Burlington Resources

Deviated Hole Diagrams

Section 1, T-29-N, R-13-W

BURLINGTON
SEC.13-T29N-R13W

WELL PROFILE DATA

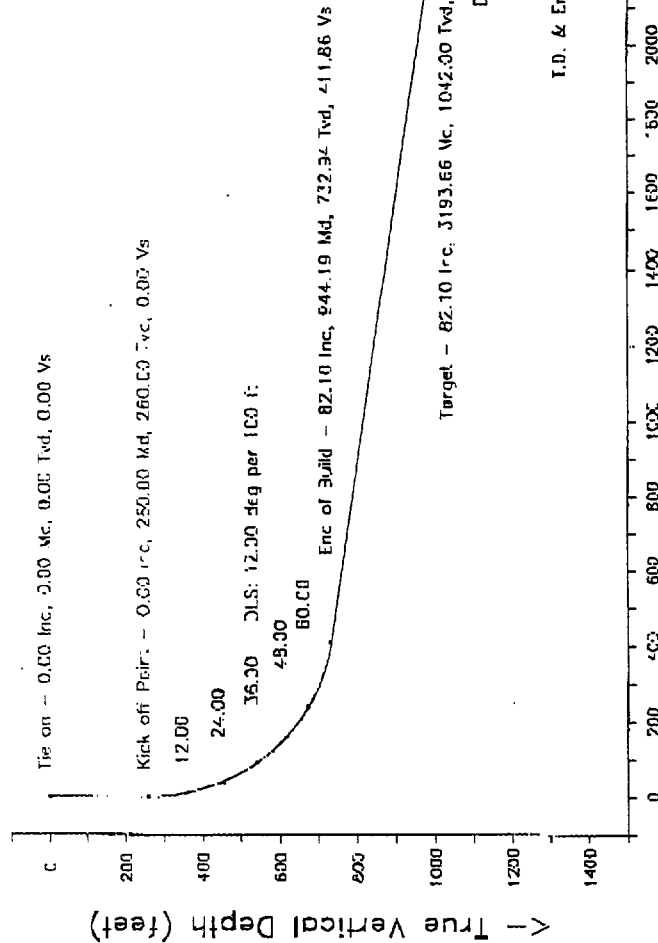
John - I don't think this is possible
- No weight in vertical hole.
